OGLE PETROLEUM INC.

RE: Production Scale Source
Material License Application
Docket No. 40-8745

SUBJECT: Biological Assessment

WILD BIRDS CRITICAL HABITAT

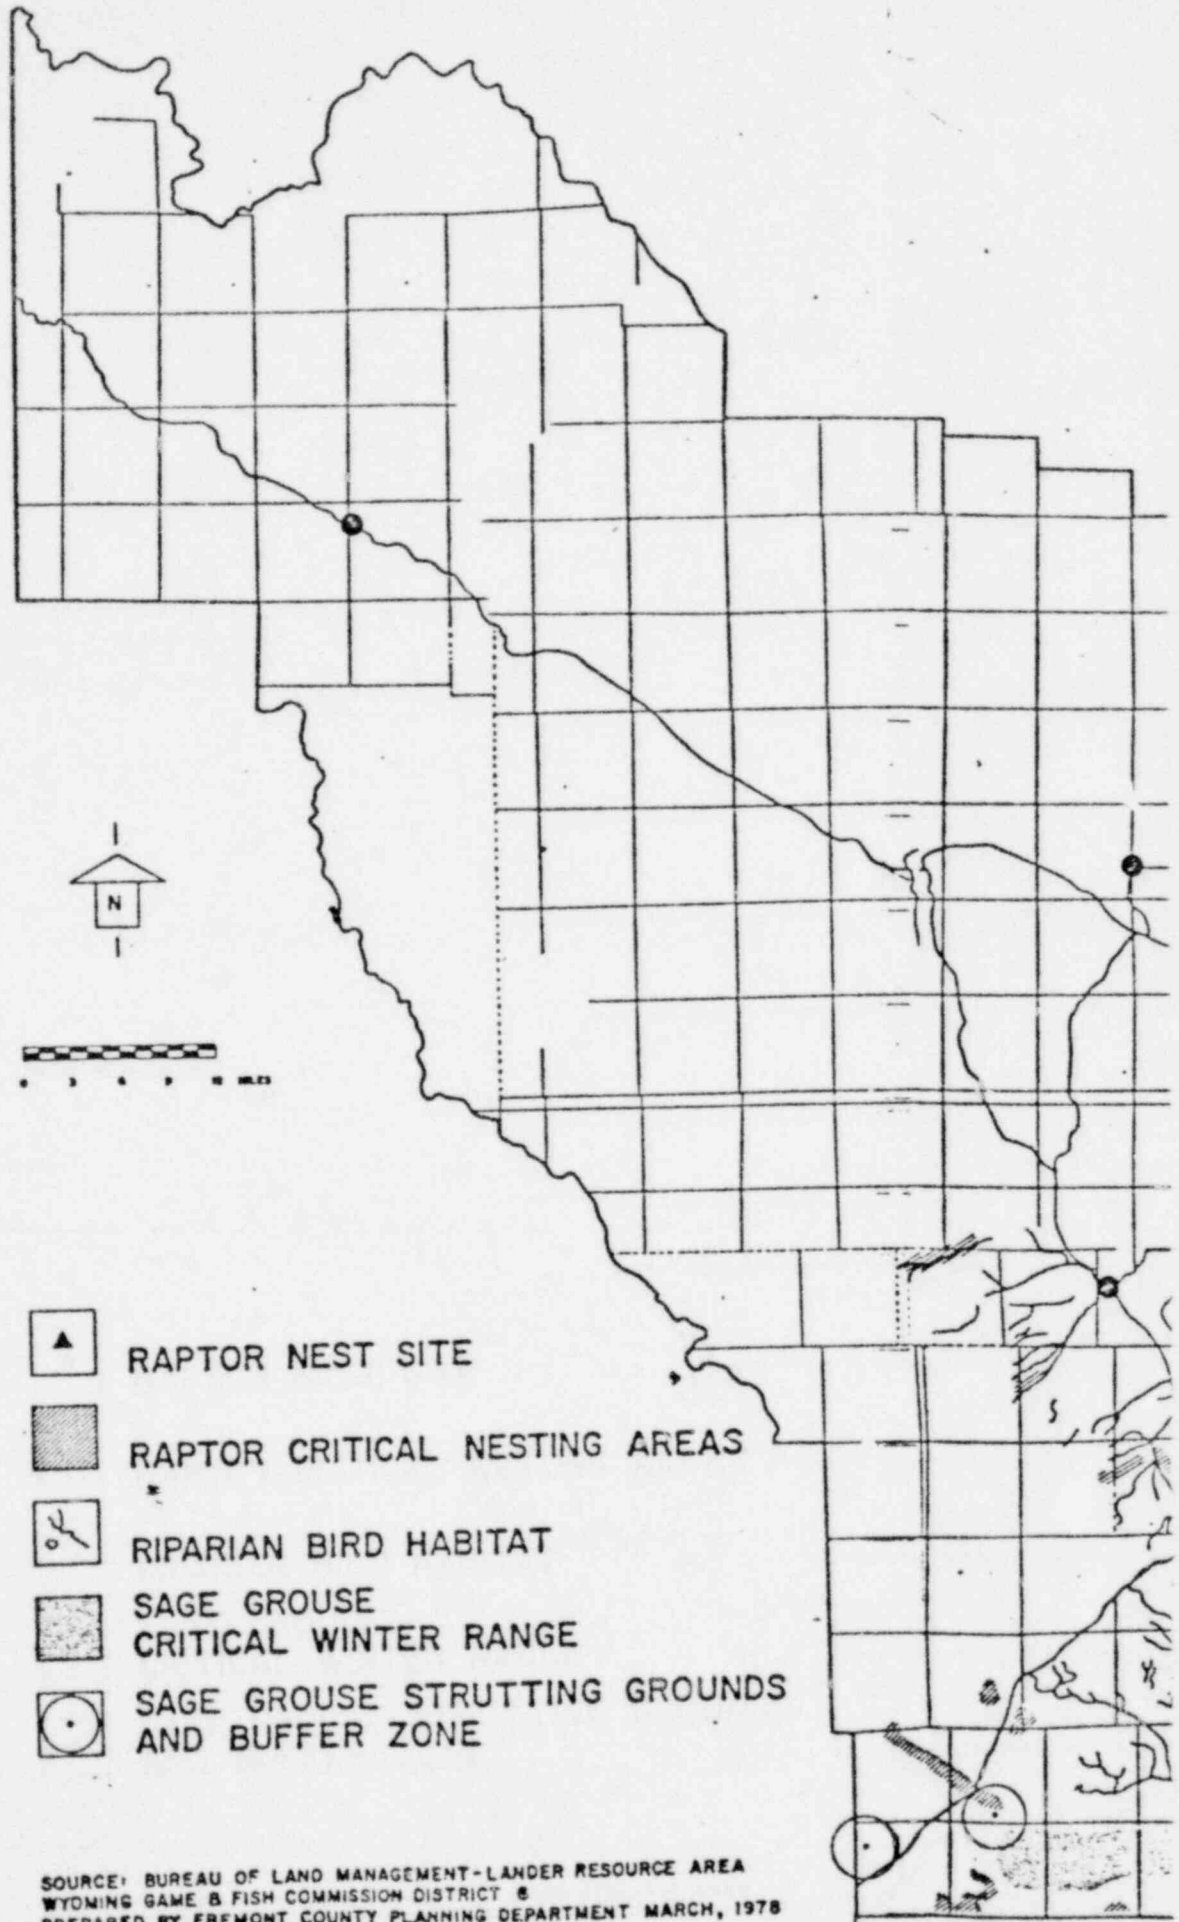
Bald Eagle: The Bald Eagle is found in small numbers throughout Wyoming. While it may be encountered almost anywhere, its preferred nesting sites are confined to elevated topographic features and on cliffs. As shown on a map, "Wild Birds - Critical Habitat", included in Fremont County Planning Commission (1978) - following page 18 thereof (copy attached hereto), the Bison Basin project area is a minimum of five miles from any raptor nest sites or raptor critical nesting areas in Fremont County. While not shown on this map, such nesting areas in Sweetwater County to the south are equally remote from the project area.
